24.0 REVISIONS TO THE DRAFT EIR/EIS

This Chapter presents a summary of the revisions that are made to the DEIR/EIS. Chapter 23 provides a list of persons, organizations, and public agencies that commented on the DEIR/EIS and responses to comments received on the DEIR/EIS.

The revisions to the DEIR/EIS include the addition of a Revised Project initiated by Homewood Mountain Resort (Alternative 1A), and corrections and edits made in response to public comments and Lead Agency review. Revisions to the DEIR/EIS were completed in track changes mode for Chapters 1 through 22 and are available for review at TRPA offices (128 Market Street, Stateline, NV), Placer County offices (565 West Lake Blvd, Tahoe City, CA), local libraries (Tahoe City Library - 740 North Lake Blvd, Tahoe City, CA; Kings Beach Library - 301 Secline Drive, Kings Beach, CA; and Rideout Community Center, 740 Timberland Lane, Sunnyside, CA) and can be downloaded for review from TRPA and Placer County websites at:

Figures 3-8A, 3-8B, and 3-8C DEIR/EIS page 3-23, FEIR/EIS pages 3-24 to 3-26: Add Figure 3-8A to show Alternative 1A North Base Area Site Plan and Fawn Street Details

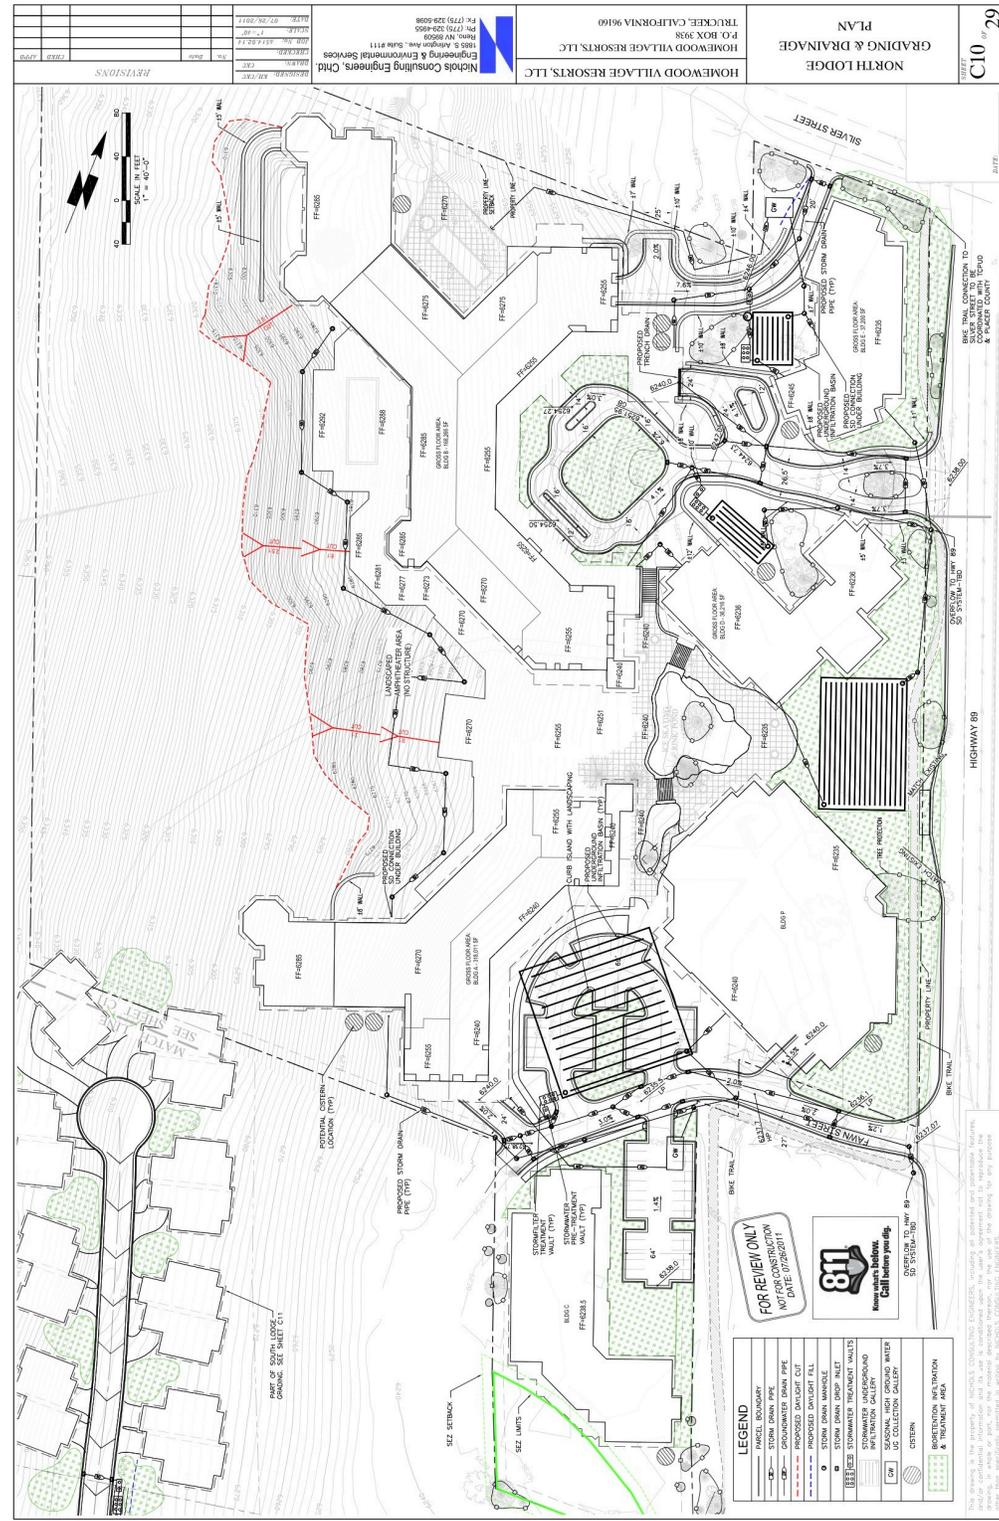
HMR has proposed modifications to Alternative 1 based on input from neighbors at the North and South Base areas. The modifications will be identified as Alternative 1A and identified in the following sections. In summary, at the North Base area, the proposed parking structure (Building P) would be moved from the existing gravel parking lot location in Alternative 1 to the SR 89 frontage just north of Fawn Street. The proposed commercial and residential building (Building C) proposed for the Alternative 1A parking structure location would be moved to the existing gravel parking lot and will only include residential condominiums and some associated surface parking spaces. The modifications would not change the number of proposed multi-family residential or tourist accommodation units, nor the amount of proposed commercial floor area. However, under Alternative 1A, the proposed condo/hotel tourist accommodation units would not include units with lock-offs as described below for Alternative 1. The total parking provided onsite would increase by 9 spaces. Figure 3-8A documents the proposed changes included in Alternative 1A.

Under the Proposed Project, day-skier access and ski resort amenities and services will be relocated to the North Base in Buildings A and B (Figures 3-7 and 3-8). The Proposed Project (Alternative 1) will provide 729 parking spaces at the North Base (with potentially up to 770 spaces provided based on final parking layout design), including 272 day use parking spaces in a four-level parking structure located adjacent to Building P, 47 limited surface parking spaces at the retail and skier drop off area, and 410 underground valet stacked and single parking spaces below the hotel and skier services buildings (Buildings A and B). The commercial/retail areas are designed to be accessible from the adjacent residential neighborhood, employee/workforce housing, and the day-skier parking structure. Alternative 1A (Figure 3-8A) provides 738 parking spaces, including 272 day use parking spaces in a four-level parking structure in Building P (located at SR 89 north of Fawn Street – Figure 3-8C), 56 limited surface parking spaces in two locations adjacent to Buildings A and C, and 410 underground valet parking spaces accessed from Fawn Street (Figure 3-8B) and the new Hotel entry drive.

The 36 residential condominiums and up to 20 fractional ownership units will be spread between ~~2 and 3-story~~ other north base buildings located adjacent to SR 89 (Buildings A, C, D and E, Figure 3-7). Alternative 1A (Figure 3-8A) locates Building C within the existing gravel parking area south of Fawn
